**SUBJECT:** ADDENDUM # 1

**PROJECT TITLE:** MEP Renovations to Jennings Hall, SCSU

**PROJECT NO.:** **BI-RS-249**

**MEP RENOVATIONS - JENNINGS HALL  
SOUTHERN CONNECTICUT STATE UNIVERSITY  
NEW HAVEN, CONNECTICUT  
PROJECT: BI-RS-249**

1 SECOND FLOOR PHASING DIAGRAM  
PH-102 SCALE: 3/32" = 1'-0"

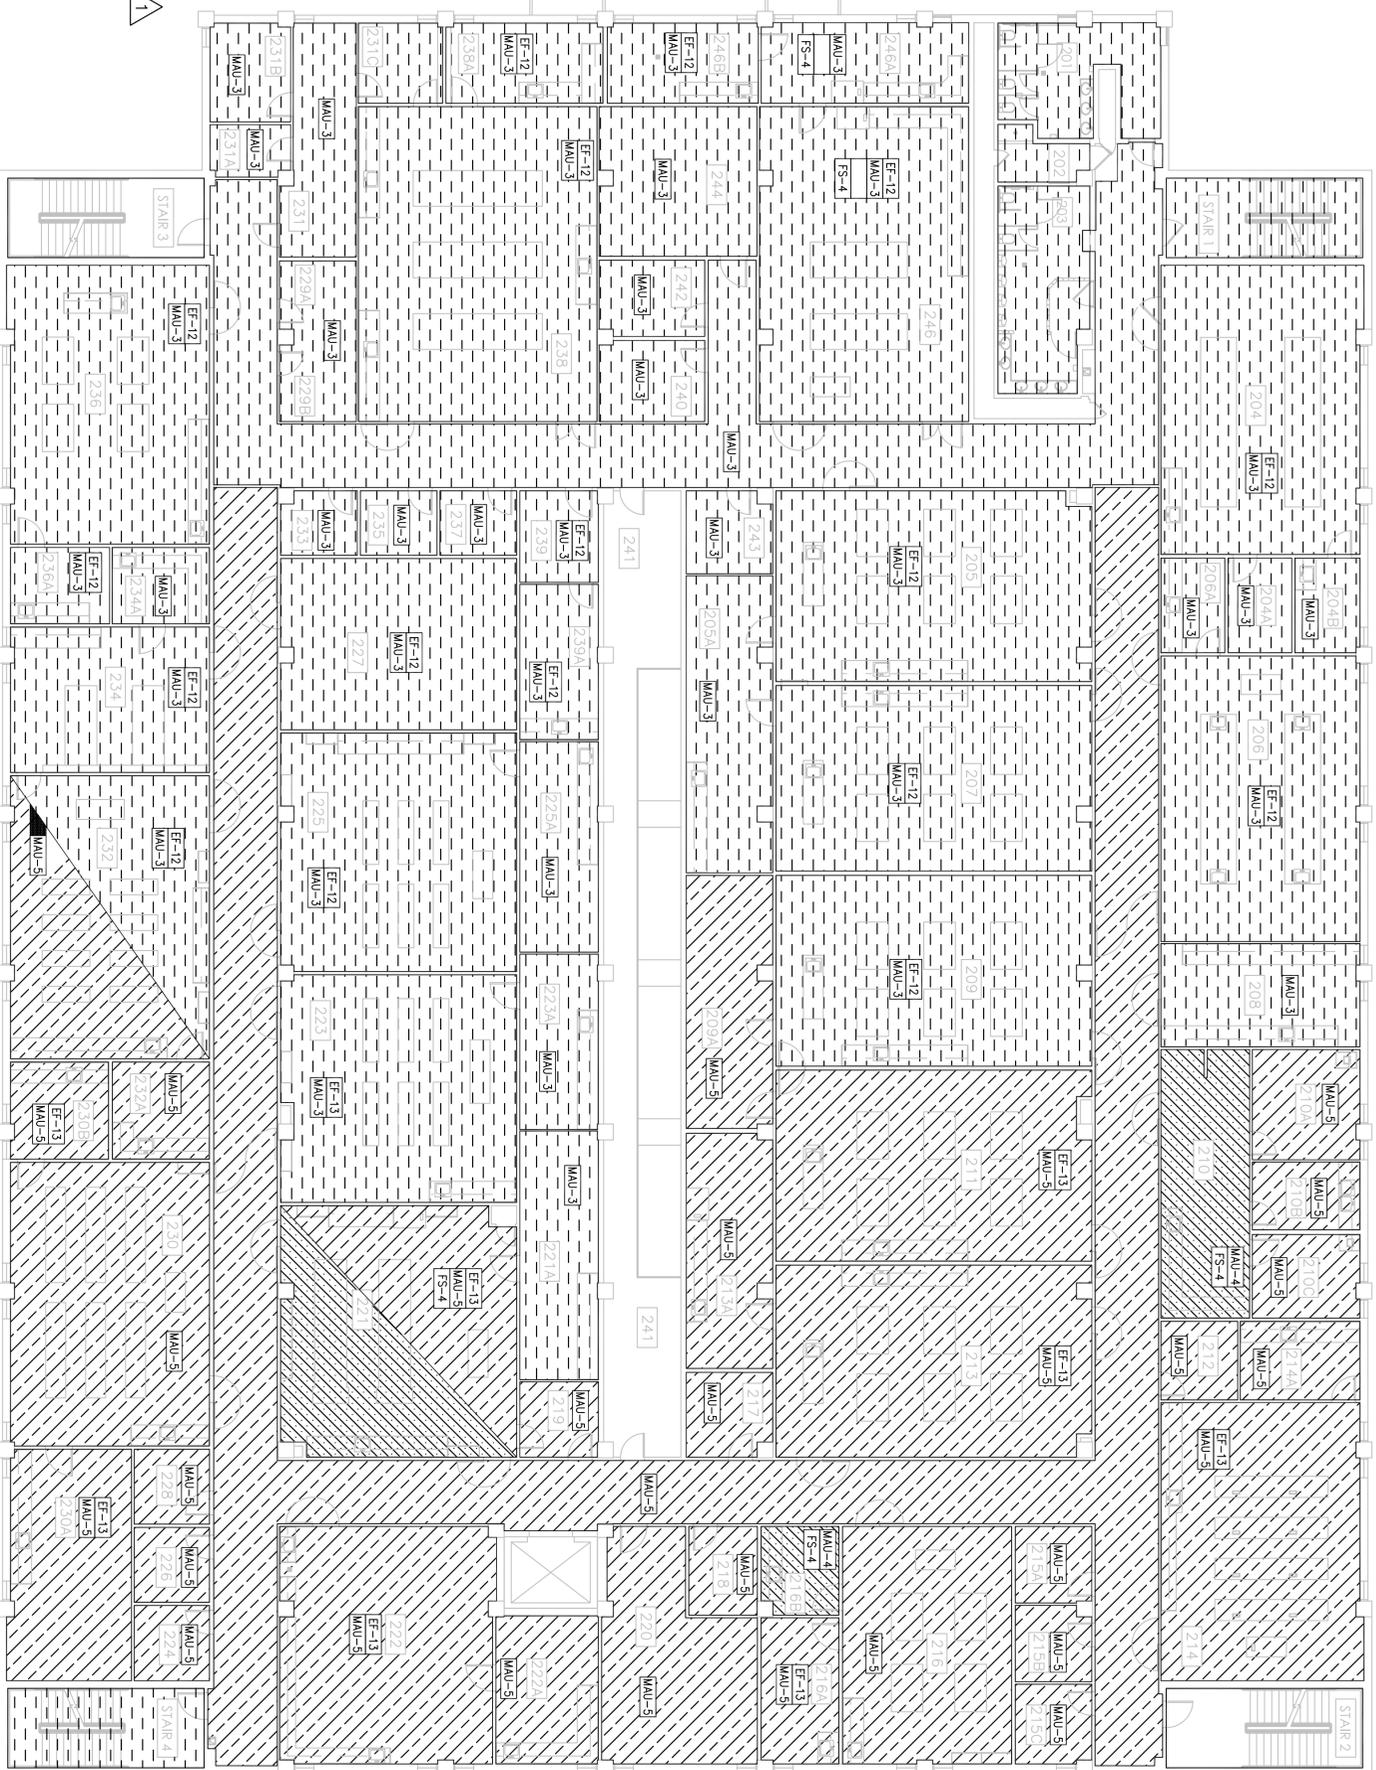
In section 011216, Work Sequence, item "T" addresses the duration of the phases of the project. Per the phasing plan there are 5 phases. The phasing notes on the drawings are the same as those in this section of the specification. During the pre-bid conference you mentioned that the project schedule might consist of a summer – winter – summer type schedule to minimize interruption to the facility. I interpreted the phasing to mean that once all the necessary materials are on hand, we could begin the construction phases and that one phase would roll to the next and so on through project completion. Your comments the pre-bid seemed to indicate starts and stops with lapses of time in between. Item "J" in this section indicates that the order and schedule of the phases will be determined at a later date prior to construction. Depending on whose interpretation of the project sequence is correct will significantly impact lost time and down time with an impact on overall general conditions costs. If the project definitely requires construction to occur only during specific months or time periods during the course of the project, this should be clearly indicated at the time of bidding.

The schedule dates and phasing has been revised. Refer to the phasing drawings PH-101, PH-102 and PH-103.

DRAWING NO:  
**SKP-1**  
DATE: 12-11-09  
SCALE: NONE

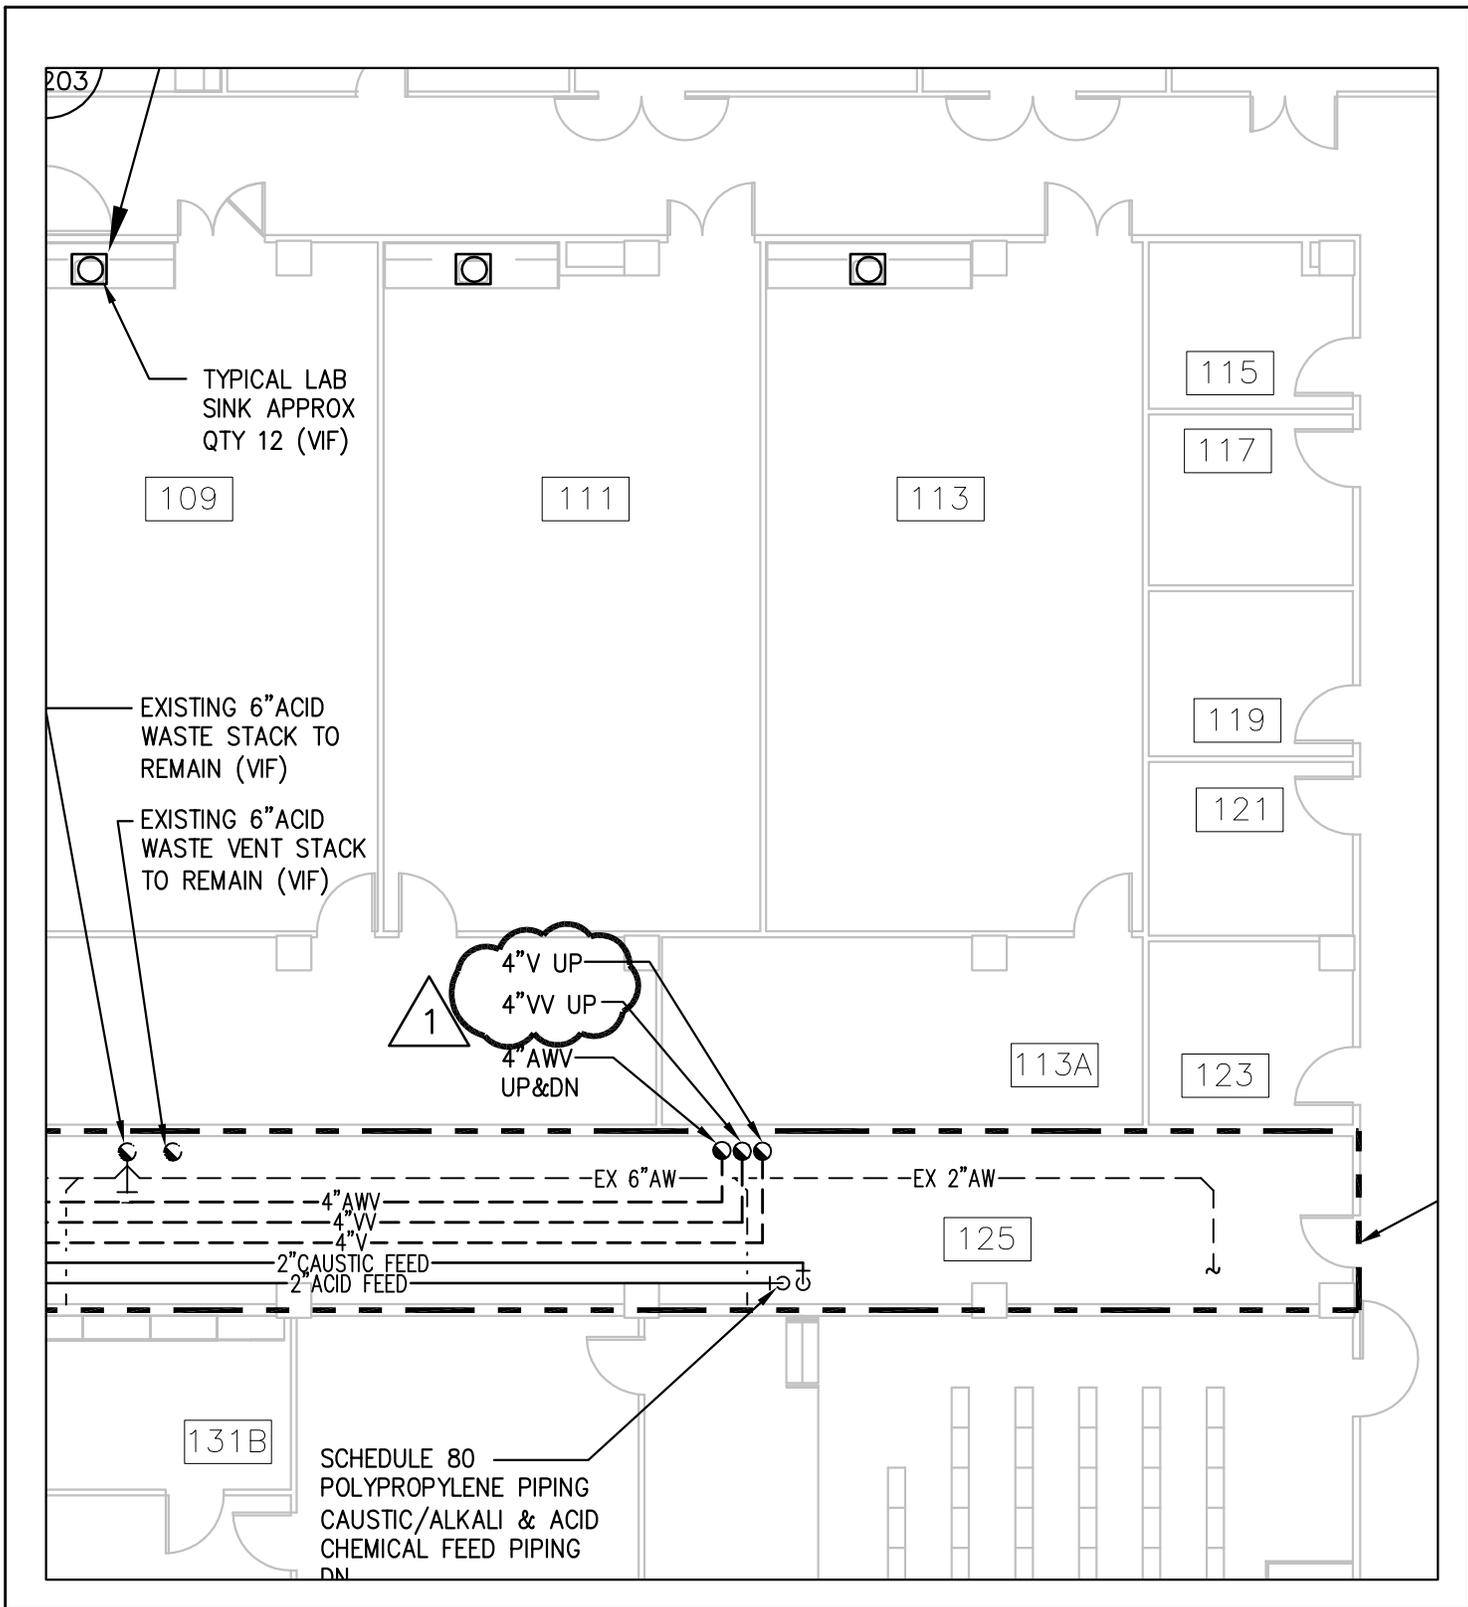
DRAWING: P-201 Detail 2: Water Heater Piping Diagram

**Revised the detail. Refer to SKP-1.**

DRAWING NO:  
**SKP-2**  
DATE: 12-11-09  
SCALE: 3/32" = 1'-0"

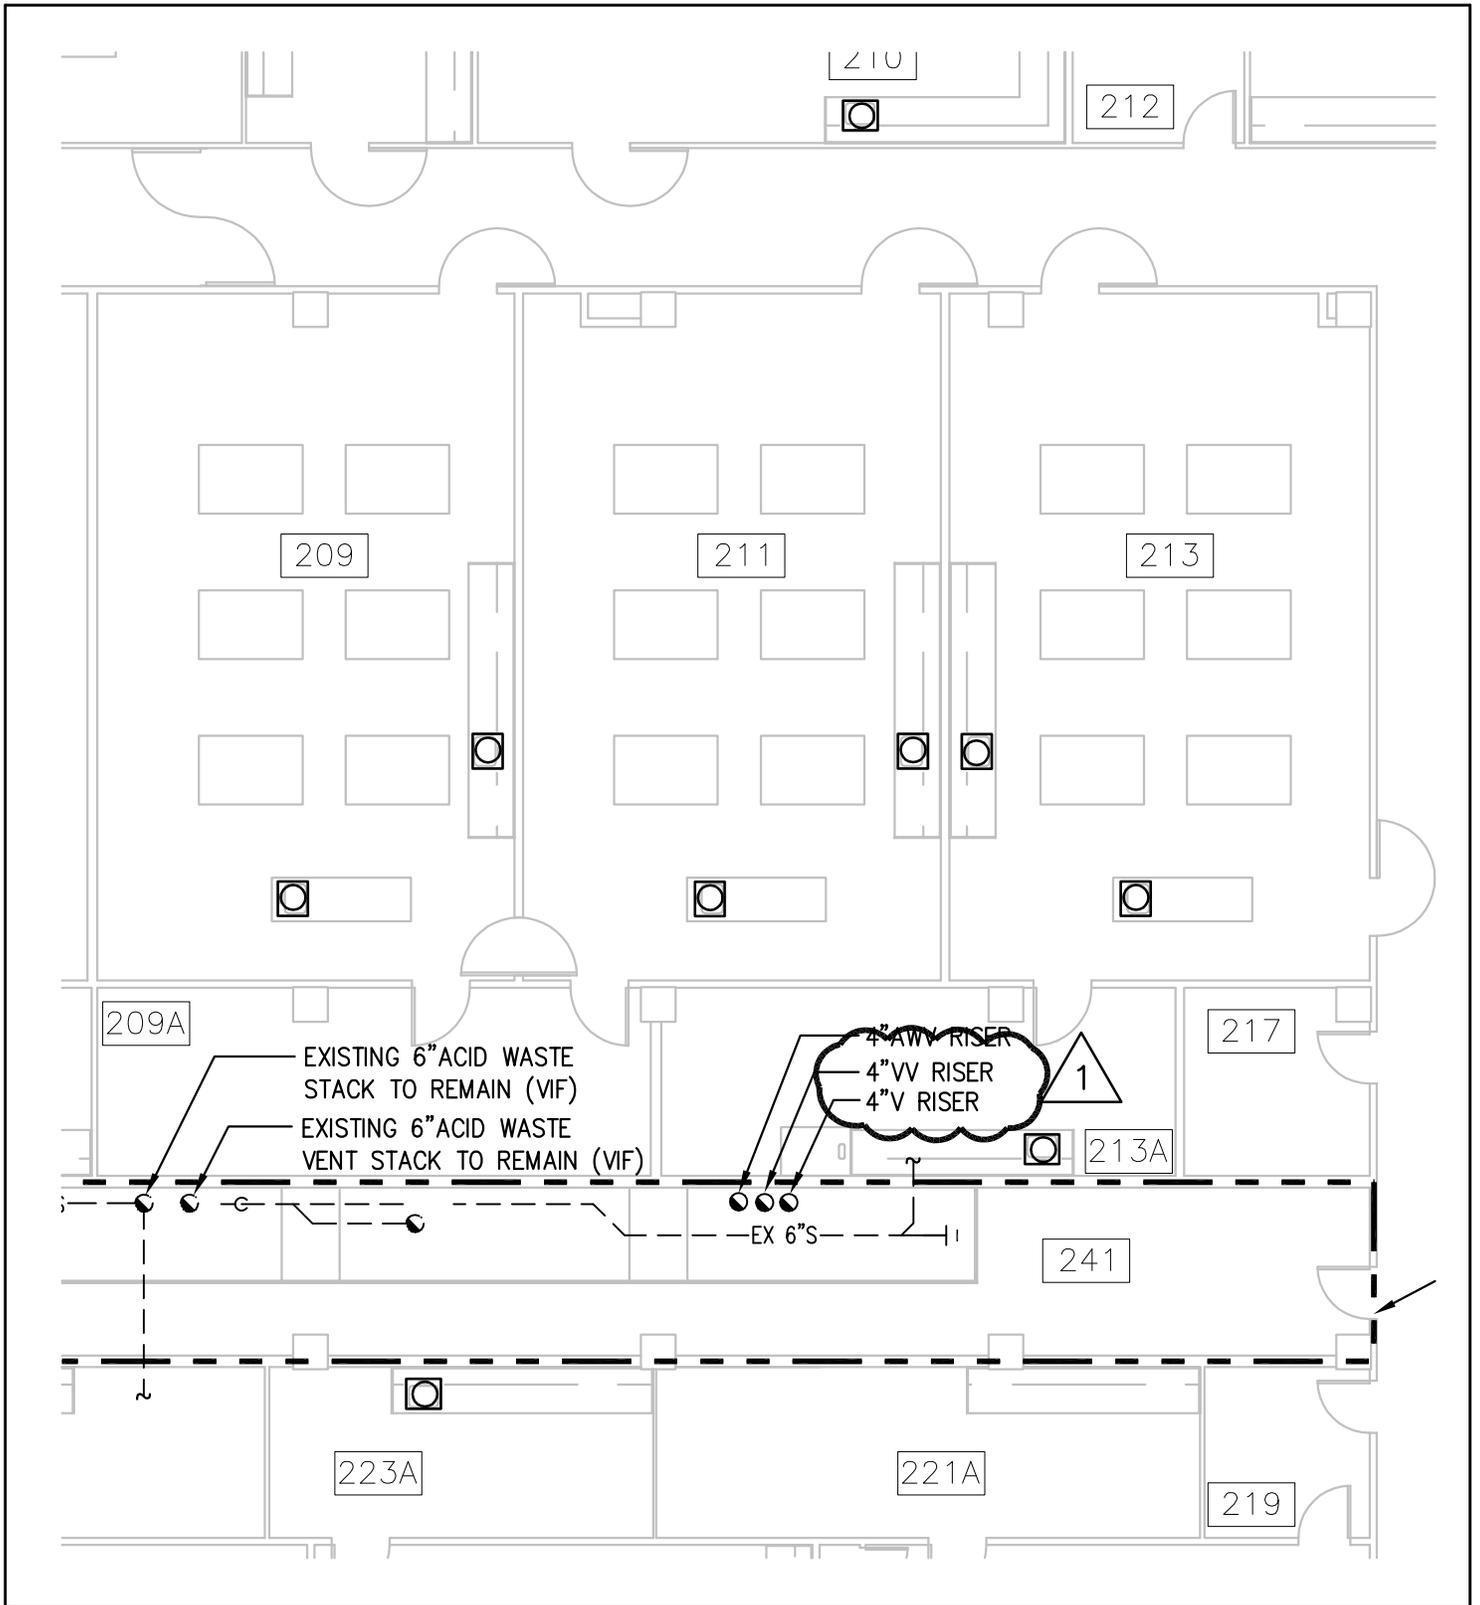
DRAWINGS: P-101, P-102, P-103, P-104

**Revised the neutralization tank vent and vault vent notation. Refer to sketches SKP-2, SKP-3, SKP-4 and SKP-5.**
